December 15, 2020

**Impacted series: Q6 & Q8 with pins V1**

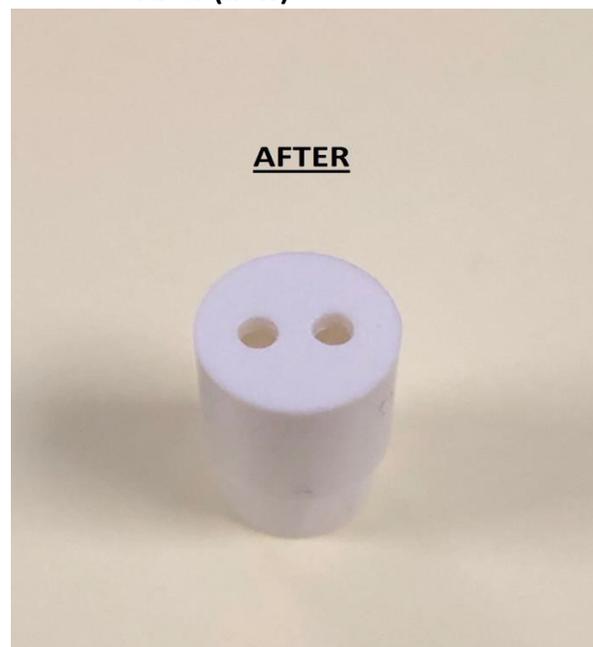
This product change notification is to inform customers' of a recent change in the manufacturing process of the Q6 and Q8 product line. If you have any questions please contact your local sales contact.

- Reduce the number of molded back bodies
- Expand the new part across our manufacturing locations
- Improve production efficiencies and reduce tool maintenance
